**Re: FortisBC Inc. (FBC)**

**Application for Approval of a Certificate of Public Convenience and Necessity for the A.S. Mawdsley Terminal Station Project (Application) ~ Project No. 1599424**

**Response to the British Columbia Utilities Commission (BCUC) Information Request (IR) No. 1**

**Figure 1: Boundary and Similkameen Areas' Peak Load Forecast, 2023-2040**

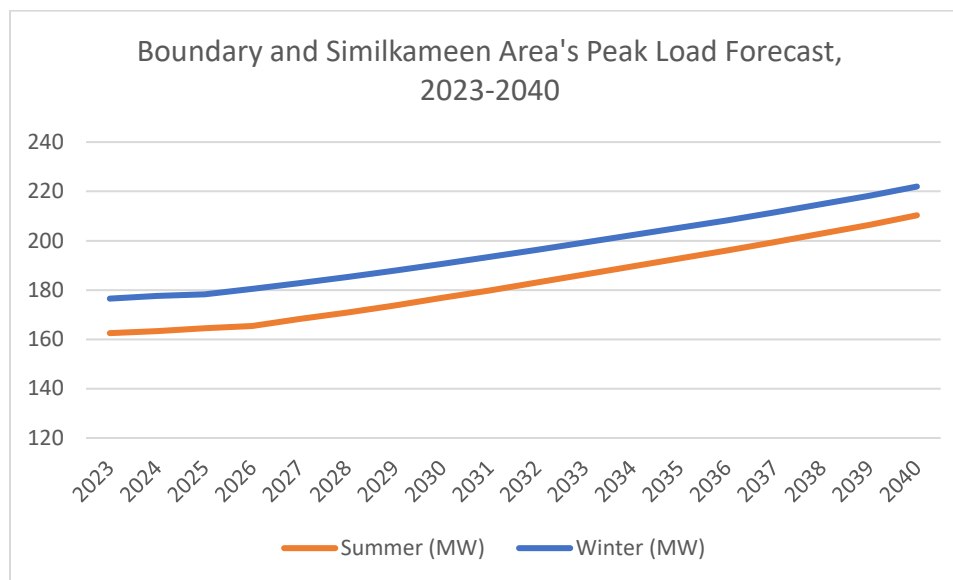
2.13 Please reproduce Table 3-3 to provide Boundary and Similkameen Areas' peak load forecast from 2023 to 2040.

2.13.1 Please provide a graphical representation of this data.

Please refer to the following Expanded Table 3-3 and Figure 1, which provide the Boundary and Similkameen areas' peak load forecast from 2023 to 2040.

**Figure 3-7: ASM Terminal Station's Contribution to the Boundary and Similkameen Areas' Total Load Compared to the N-1 Transformer Limits<sup>13</sup>**

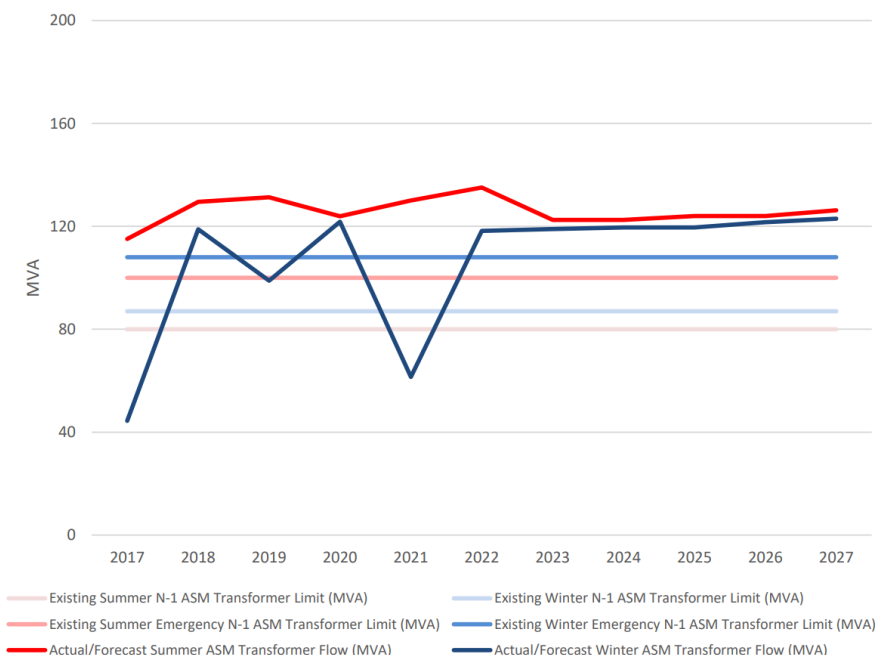
2.19 Please reconcile Tables 3-2 and 3-3 with Figure 3-7 and FBC's statement that "on average the Boundary and Similkameen areas are supplied 67 percent of their load in the winter and 75 percent of their load in the summer by the ASM Terminal Station."

Tables 3-2 and 3-3 show the historical and forecast values of the Boundary and Similkameen area loads. The Boundary and Similkameen area loads are only one factor that determines the loadings of the ASM transformers. The other factors that affect the ASM transformer loadings are the provincial generation dispatch (with Waneta Hydro Station generation having the greatest impact) and the system configuration at that time.

The historical values shown in Figure 3-7 are the actual ASM transformer loading values for years 2017-2022.

These average percentages were then multiplied by the forecast values in Table 3-3 to produce the forecast values in Figure 3-7.

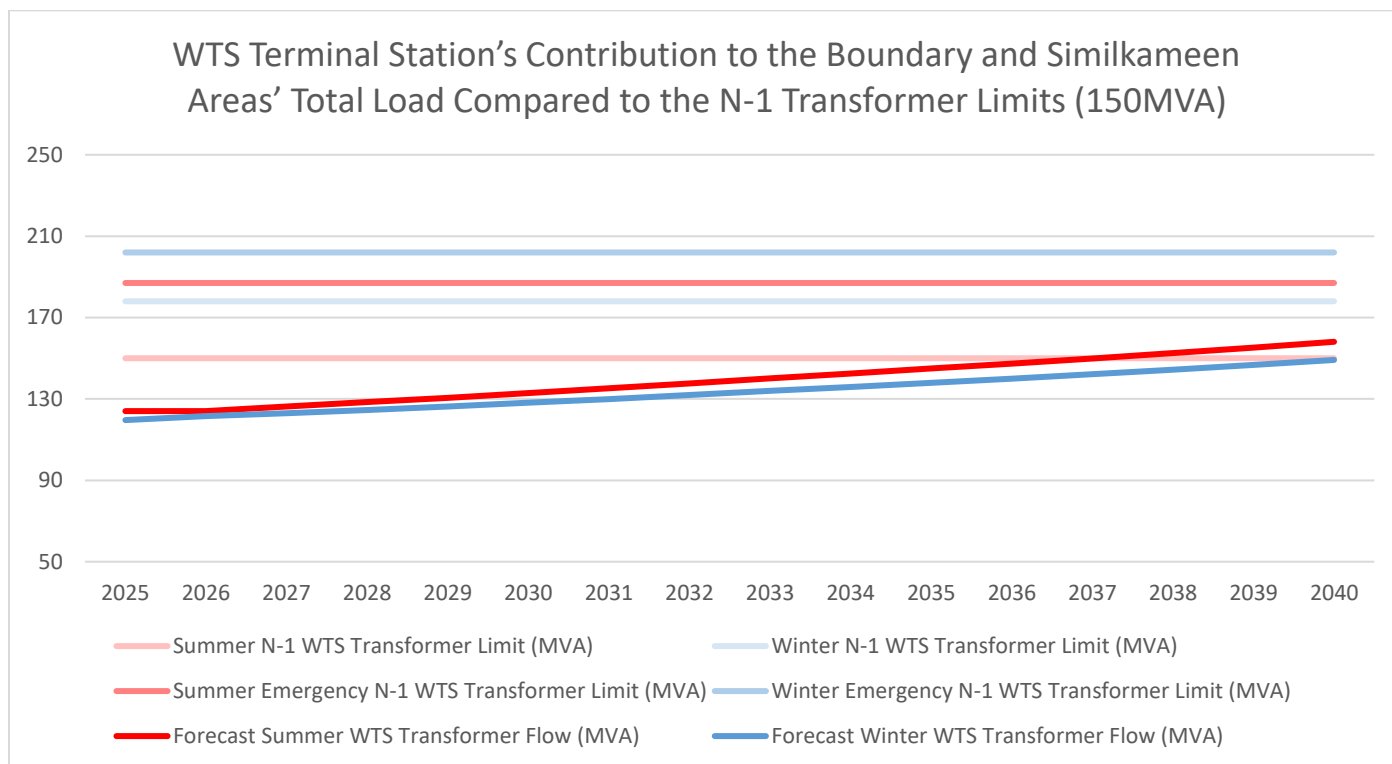
2.22 Please produce a graph similar to Figure 3-7 that displays the following information from Project completion to 2040 for WTS:

- i. Forecasted load at WTS;
- ii. Summer and Winter N-1 limits and N-1 emergency limits.

Please refer to the following figure.

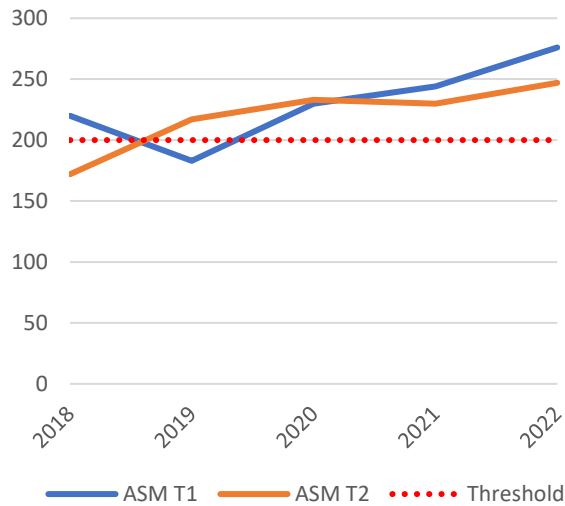
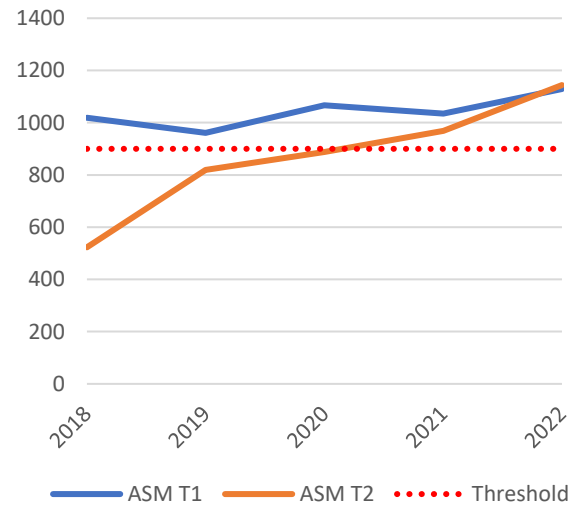
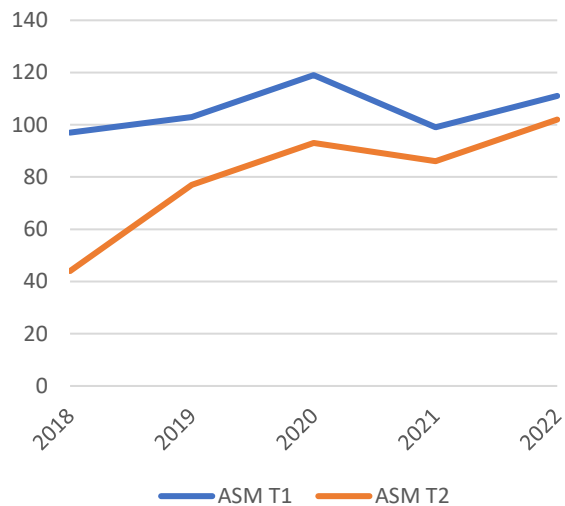
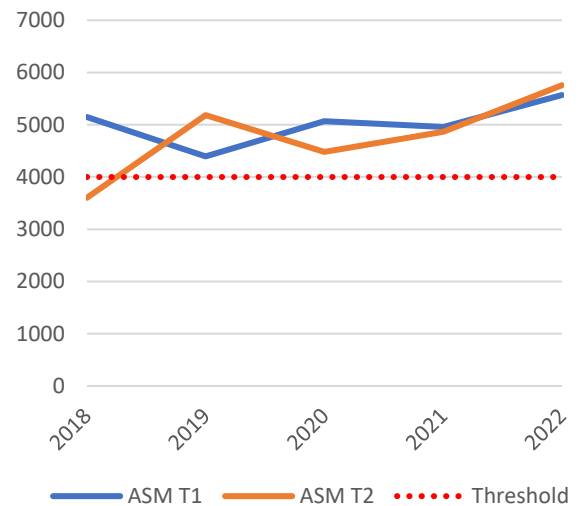
3.6.1 Please provide any additional evidence to support the statement “the condition of both transformers continues to deteriorate with age, with their risk of failure increasing with each passing year.”

FBC considers the evidence provided in the Condition Assessment Report (Appendix B to the Application) and described in Section 3.3 of the Application to fully support the need for the Project to address the risk of failure posed by the deteriorating condition of the ASM transformers. In particular, FBC highlights the following:

1. The Condition Assessment Report indicates that insulation loss of life is a cumulative process, related to loading and operation. Based on historical and forecasted loading, the annual insulation deterioration trends anywhere between 0.1 and 0.8 percent. System conditions which result in overloading of either of the two ASM units will dramatically decrease life expectancy.

**Figure 5-1: Proposed WTS Simplified Single Line Diagram**

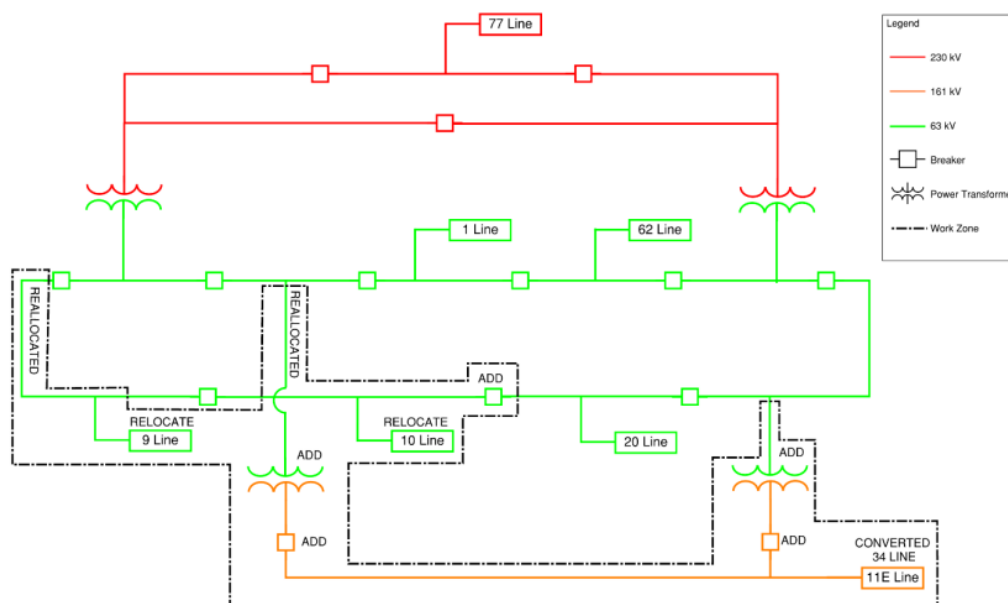
9.1 Please provide rationale for WTS stepping down from 230 kV to 63 kV before stepping up from 63 kV to 161 kV.
